RE: Property located at 9403 Brenda Ann Road 7
FILE: 7868A
PARCEL: 113-163-05PO

MECKLENBURG COUNTY ENVIRONMENTAL HEALTH
SITE EVALUATION REPORT
SERIAL NUMBER 12366

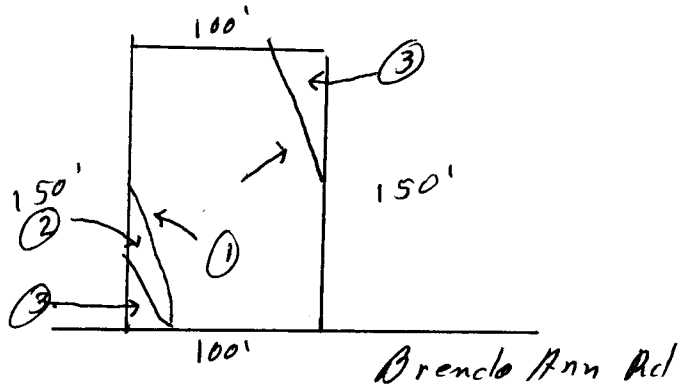
Comments: Would require well

FACTORS	AREA 1	AREA 2	AREA 3	AREA 4	AREA 5	AREA 6
Topography	(S) PS U 6-15%	S PS (U) complex slopes	S PS (U) Depression	S PS U	S PS U	S PS U
Texture	S (PS) U Slightly Expansive clay	S PS U	S PS U	S PS U	S PS U	S PS U
Structure	S (PS) U Subsoil Blocky	S PS U	S PS U	S PS U	S PS U	S PS U
Drainage	(S) PS U 7+8" To water	S PS U	S PS U	S PS U	S PS U	S PS U
Depth	(S) PS U 7+8" @	S PS U	S PS U	S PS U	S PS U	S PS U
Restrictive Horizons	(S) PS U 7+8"	S PS U	S PS U	S PS U	S PS U	S PS U
Available Space	S PS (U) Restricted	S PS U	S PS U	S PS U	S PS U	S PS U
Other (specify)	S PS U	S PS U	S PS U	S PS U	S PS U	S PS U
Soil Group/Series	IIe Cecil-Lille	complex slopes	Depression			
Area Classification	S PS (U)	S PS (U)	S PS (U)	S PS U	S PS U	S PS U
